UNCLASSIFIED NPRDC-TN-80-7

6
**ANALYSIS OF LSD-41
MACHINERY ROOM LAYOUT.**

**ANALYSIS OF LSD-41
MACHINERY ROOM LAYOUT**

This analysis was conducted as a preliminary step in the development of machinery rooms for the LSD-41. Tentative layouts of the machinery rooms had been prepared by both NAVSEA and the J. J. Henry Company. This report describes the advantages and disadvantages of the concepts depicted in these layouts. A key factor involved in selecting one concept over the other is the extent to which they conform to established human engineering principles and practices.

Fig. 1: NAVSEA MACH. ROOM No.1

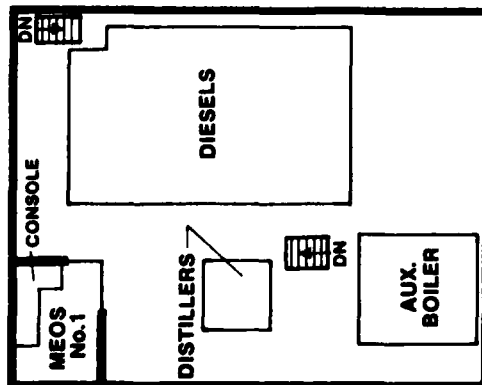
1. The NAVSEA layout permits the use of identical wrap-around consoles in MEOS #1 and #2.

2. A seated operator in MEOS #1 can view the machinery space by rotating in his chair 180°.

2. The orientation of the two MEOSs differ. In MEOS #1, the operator has his back to the machinery space; in MEOS #2, he faces the machinery space.

3. Windows should be installed in the MEOSs as depicted in Figures 1, 5, 6, and 7.

Fig. 3: J. J. HENRY MACH. ROOM No.1

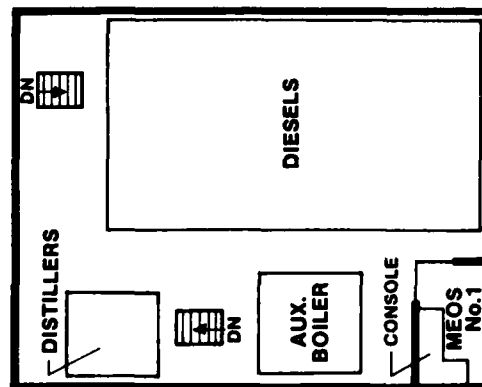
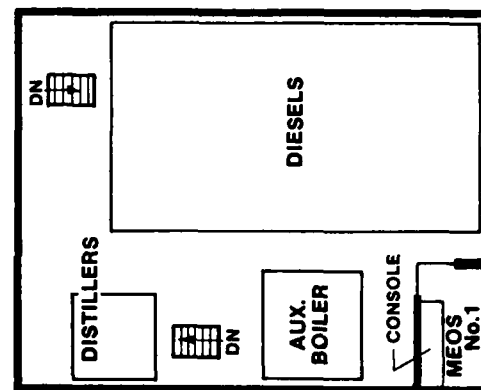
1. In both MEOS #1 and MEOS #2, the seated operator faces the machinery space. Orientations of the machinery space relative to the operator are more nearly alike than in the NAVSEA layouts.

2. Ladders to the lower level are not immediately accessible to the MEOSs.

2. If the J. J. Henry layouts are selected, straight consoles as in Figures 6 and 7 should be used.

Fig. 2: NAVSEA MACH. ROOM No.2

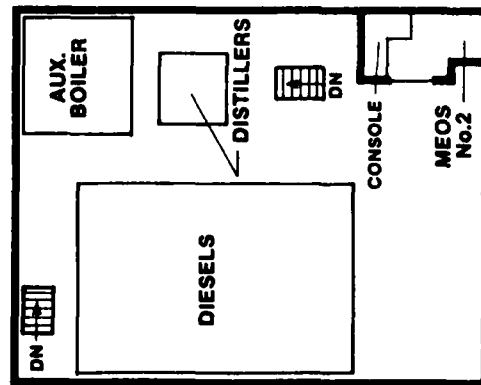
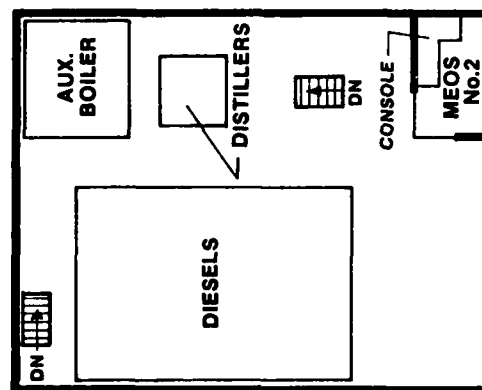
1. The console in MEOS #2 fills the entire forward area, thus preventing the installation of a window to enable the operator to view the machinery space.

Although it is not essential for the seated operator to directly view the machinery space, installing windows overlooking this area is considered worthwhile for psychological reasons. Because of the minimal amount of information that could be obtained from such windows, however, development of special consoles that would permit their installation in the NAVSEA MEOS #2 is not warranted.

If the NAVSEA layouts are adopted, the MEOS #2 should be modified to approximate the layout presented in Figure 5, which would permit the installation of forward-looking windows overlooking the machinery space. If the J. J. Henry layouts are adopted, straight consoles should be used, as indicated in Figures 6 and 7. Satisfactory results should be obtained with either the NAVSEA layouts with wrap-around consoles or the J. J. Henry layouts with straight consoles. Provided that the recommended changes are made, final selection of the layouts should be based on factors other than human engineering.

1. If the NAVSEA layouts are selected, MEOS #2 should be modified to resemble the layout in Figure 5. Wrap-around consoles may be used.

Fig. 4: J. J. HENRY MACH. ROOM No.2

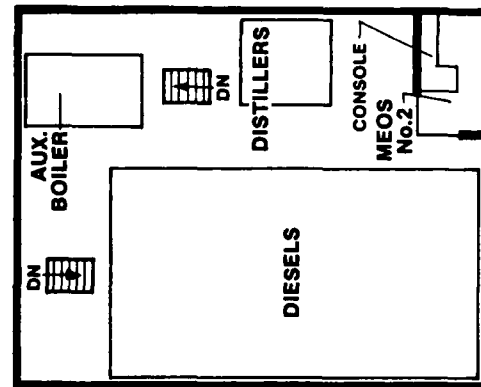
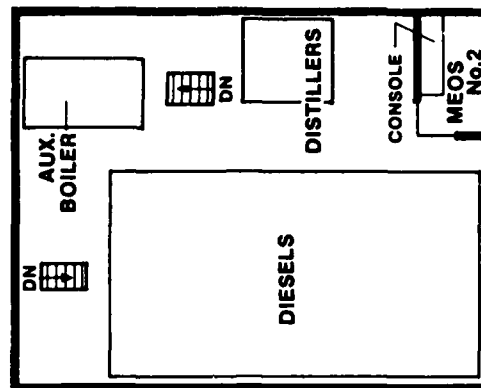
2. Configuration of the J. J. Henry MEOS #2 is better than that of the NAVSEA MEOS #2. Because of the location of the console in the J. J. Henry layout, a window overlooking the machinery space can be installed.

1. The use of identical wrap-around consoles is not feasible. If the console is placed so as to permit a window to be installed overlooking the machinery space, as in Figure 4, one wing of the console would extend out into the room. This would restrict movement of personnel and communication among personnel.
